VIRGINIA ELECTRIC AND POWER COMPANY
RICHMOND, VIRGINIA 23261

VIRGINIA ELECTRIC AND POWER COMPANY
SURRY POWER STATION UNITS 1 & 2
CORE UPDATE LICENSING REPORT REVISION
STEAM GENERATOR TUBE RUPTURE REANALYSIS

**SURRY CORE UPRATE LICENSING REPORT
TABULATION OF CHANGES**

**SURRY CORE UPRATE LICENSING REPORT
REVISED PAGES**

Figure 3.5.9-1

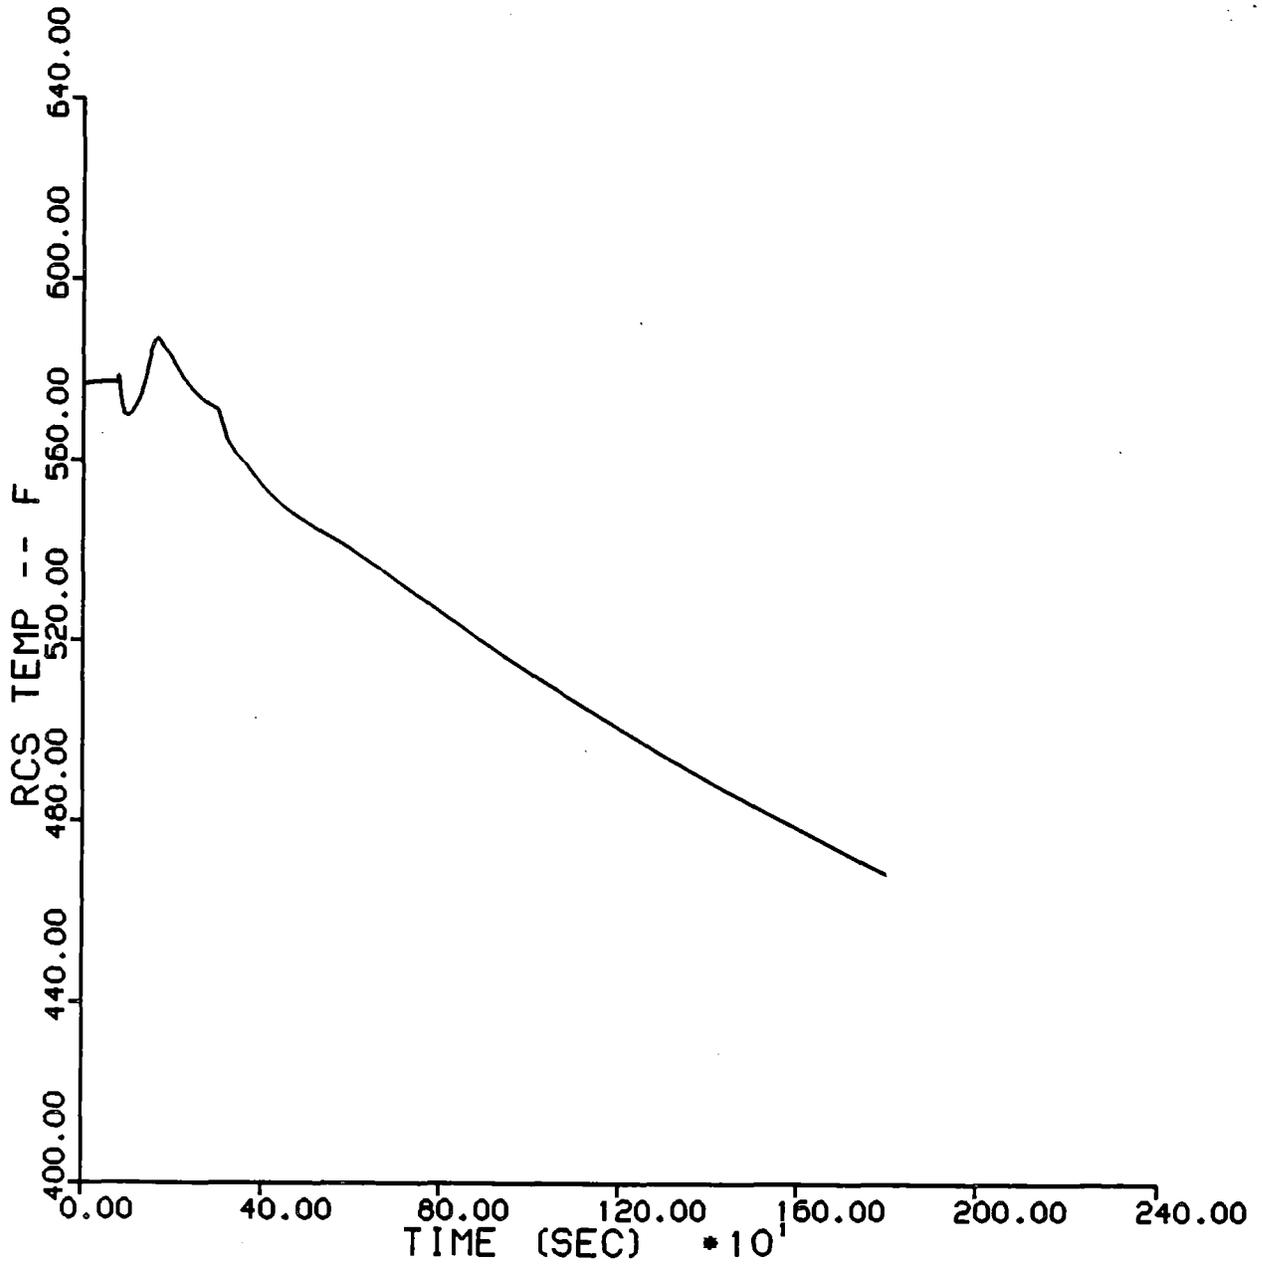
Figure 3.5.9-1 - RCS Average Temperature: Following the rupture, RCS temperature is relatively stable until the unit trips on overtemperature ΔT at 73.9 seconds. The turbine stop valves are assumed to close within the next 2 seconds. Temperature continues to decrease in response to addition of cold safety injection water (safety injection occurs in response to low pressurizer pressure at 289 seconds) and the release of steam through the stuck open PORV (the PORV opens at 88.1 seconds). In actual operating practice, additional cooldown would be imposed by the operators as directed by the emergency procedures to support primary side depressurization to reduce the break flow.

Figure 3.5.9-2

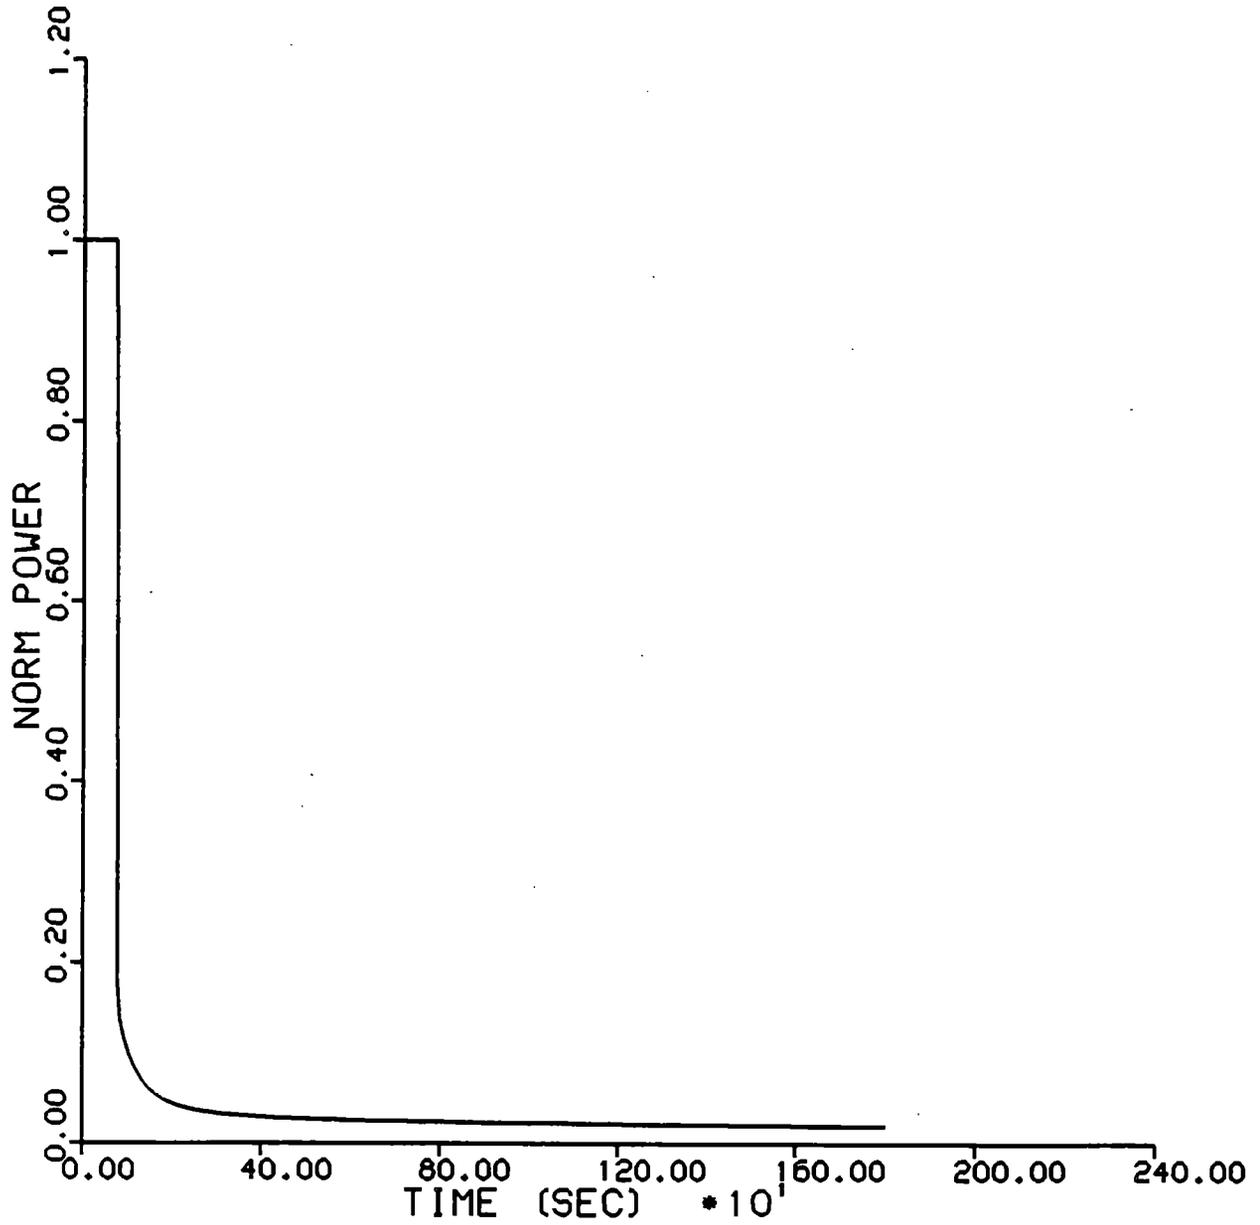
Figure 3.5.9-2 - Reactor Normalized Power: As discussed above, reactor trip is on overtemperature ΔT at 73.9 seconds.

Figure 3.5.9-3

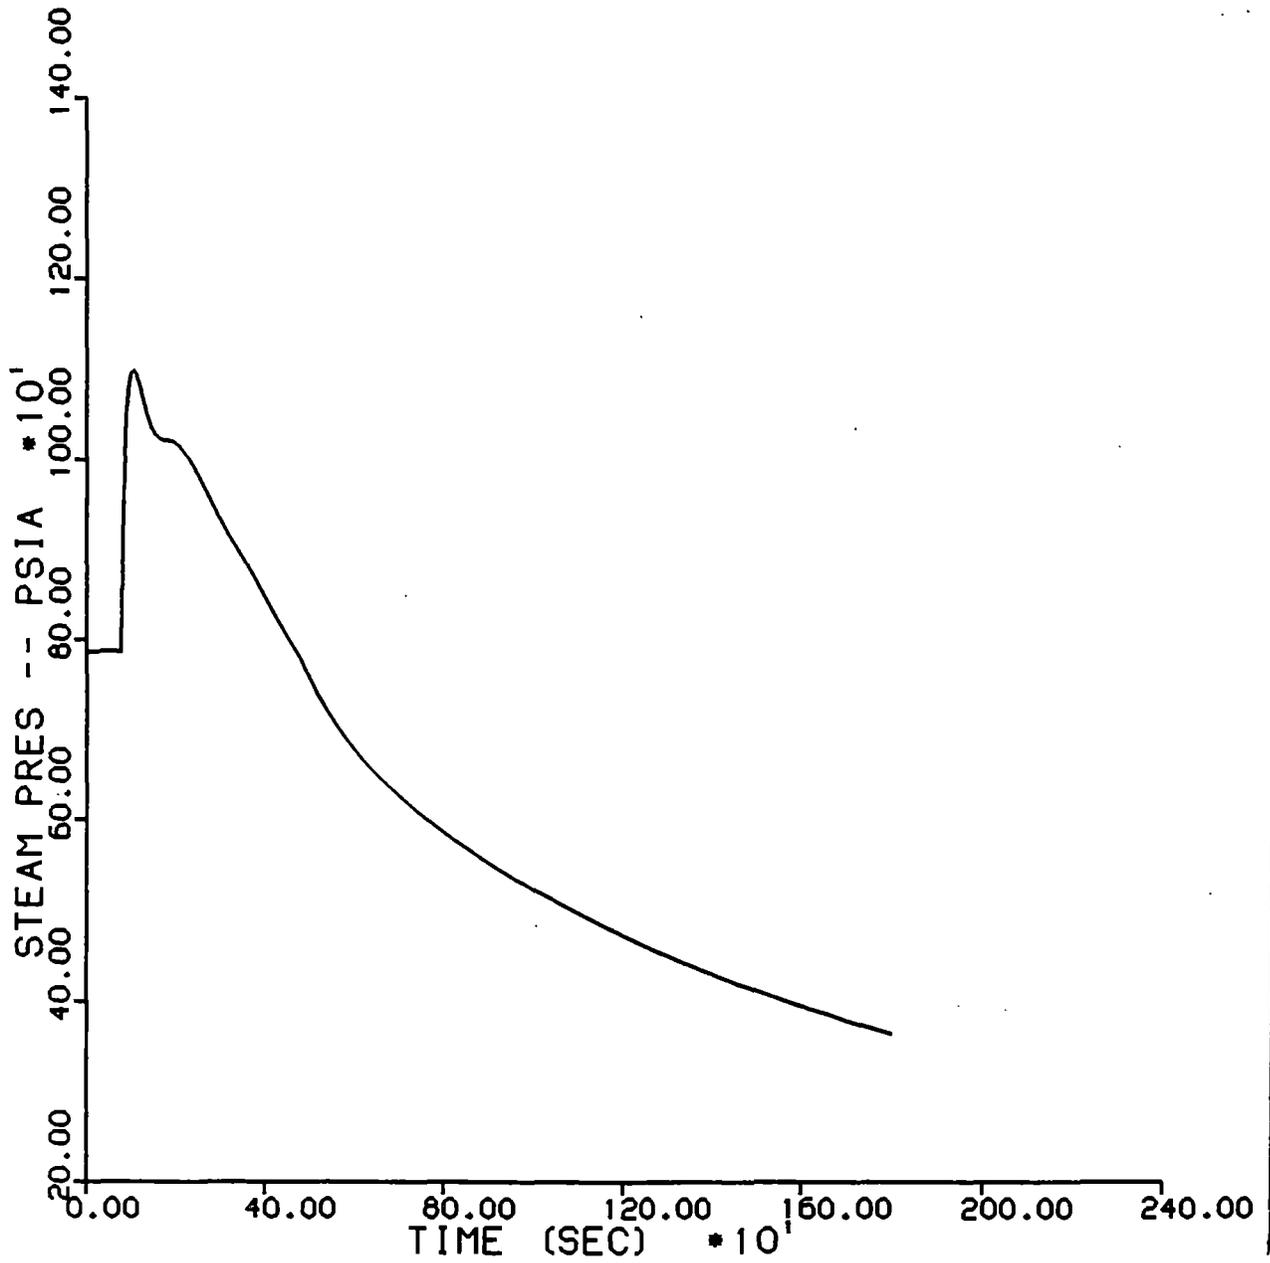
Figure 3.5.9-3 - Ruptured Loop Steam Pressure: After the reactor and turbine trip, pressure in the steam generator initially increases. The expected response would be an increase followed by stabilization at the no-load pressure of about 1005 psig, but since the analysis assumes an atmospheric dump sticks open, there is a gradual depressurization.

Figure 3.5.9-4

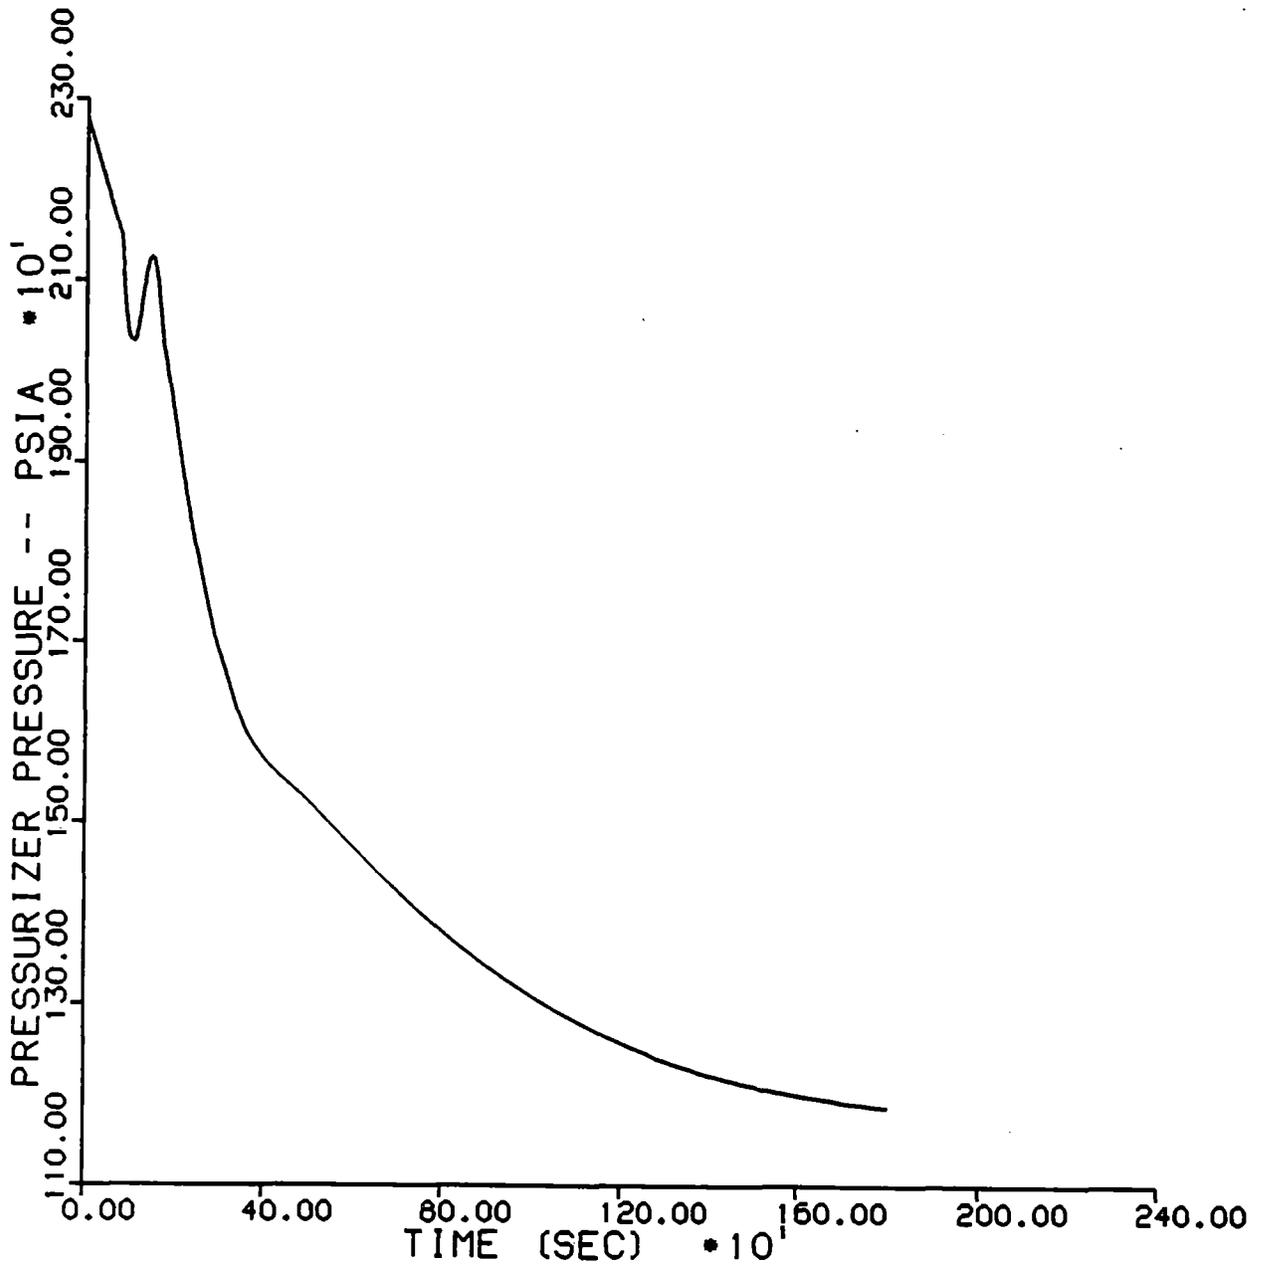
Figure 3.5.9-4 - Pressurizer Pressure: The initial drop in pressurizer pressure results from excess of tube rupture flow over the charging flow. The pressurizer level controller, which would increase charging flow and tend to retard this initial depressurization, is not modeled. Immediately following reactor trip the depressurization rate is accelerated. Safety injection is initiated on low pressurizer pressure, the depressurization drops significantly as a result.

Figure 3.5.9-5

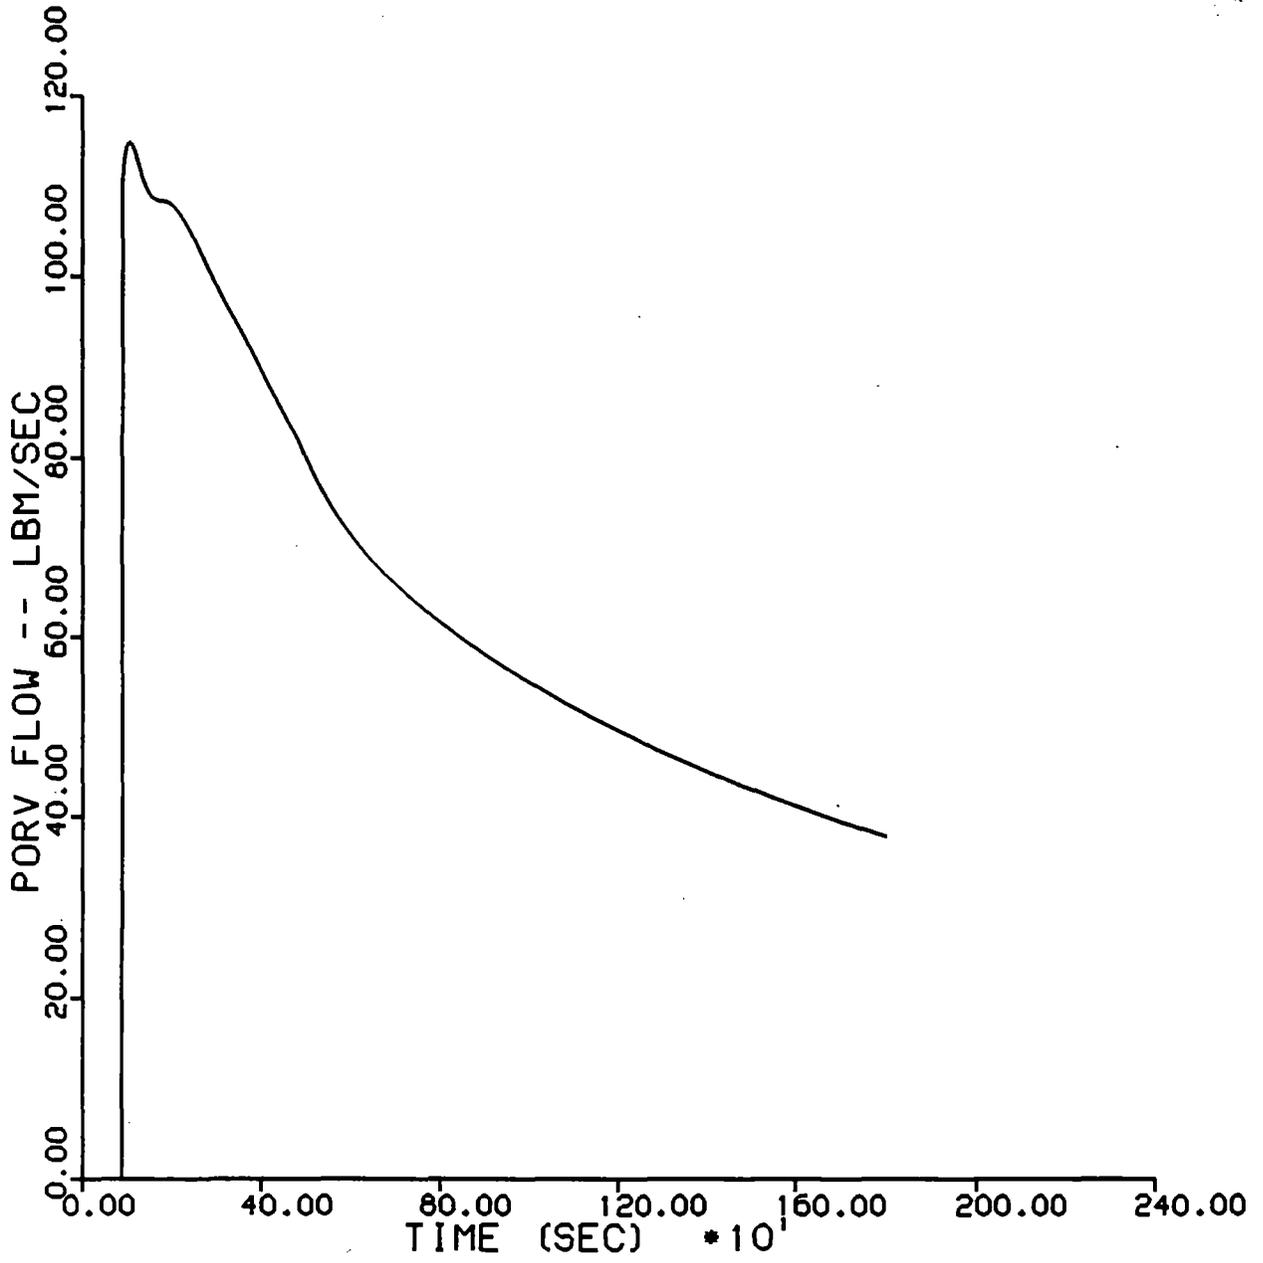
Figure 3.5.9-5 - Flow Through the Stuck Open PORV: This represents the primary potential source of radioactivity transport to the environment if the condenser steam dumps are not available.

Figure 3.5.9-6

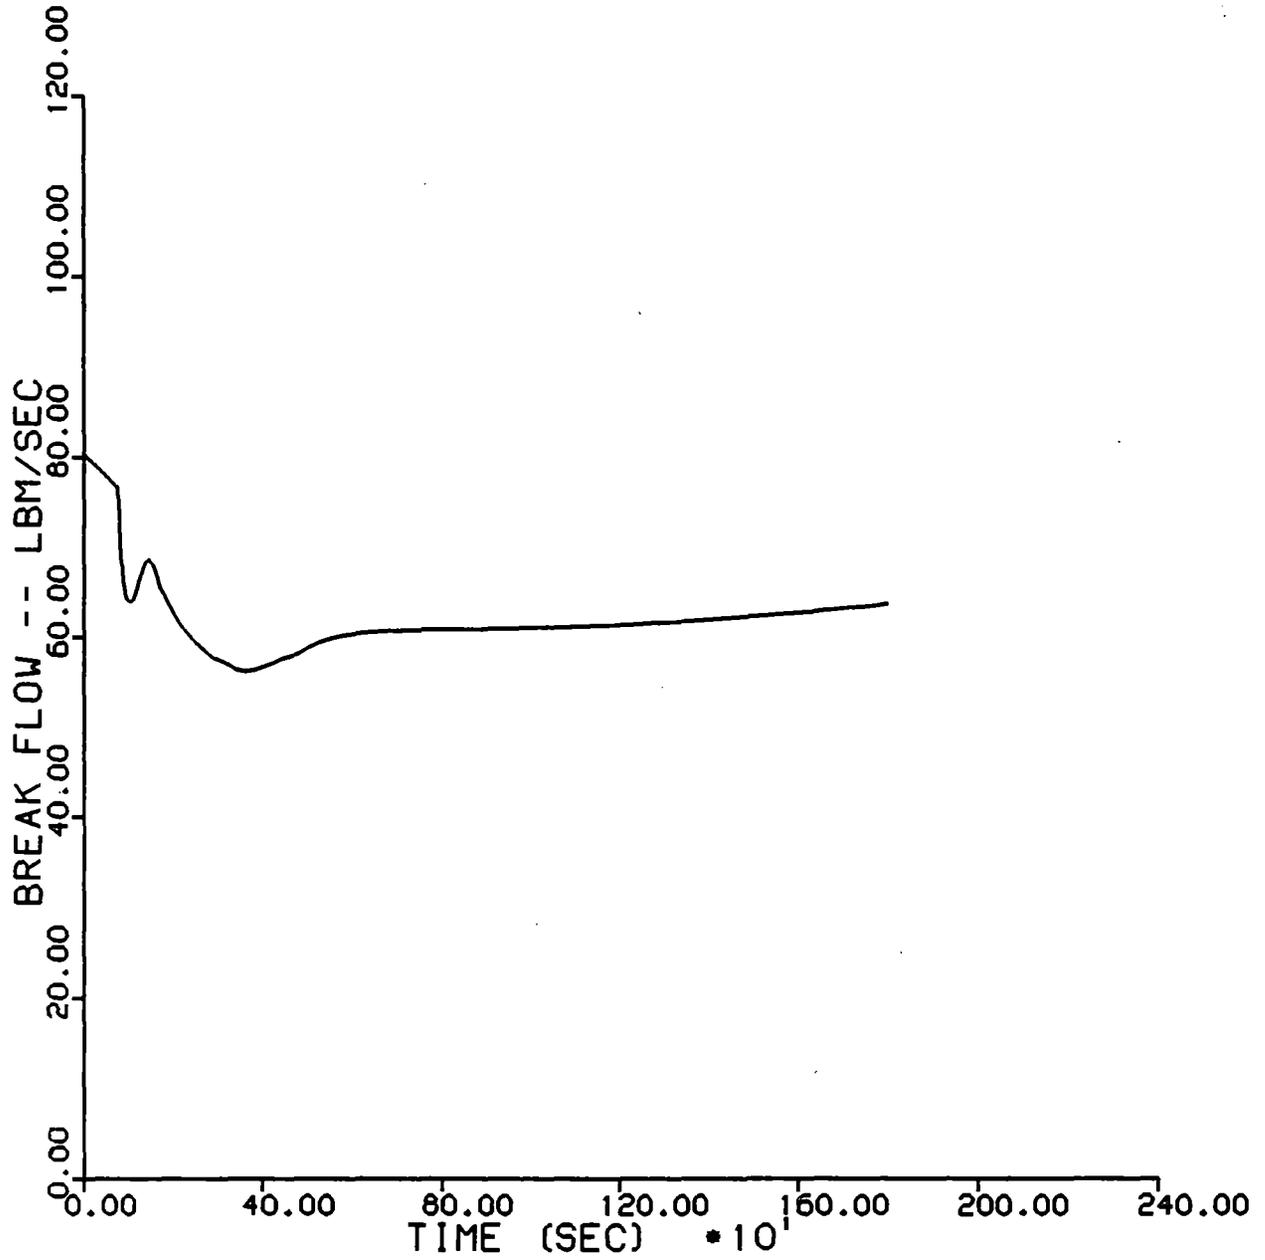
Figure 3.5.9-6 - Break Flow: The initial break flow through the two ends of the ruptured steam generator tube is about 80 lbm/sec or approximately 800 gpm. The flow drops off quickly in response to the RCS depressurization until safety injection is initiated. Then the flow stabilizes, as equilibrium between the break flow and safety injection is established, at about 550 gpm. The slight increasing trend in mass flow beyond this point is a result of increased fluid density due to the RCS cooldown.
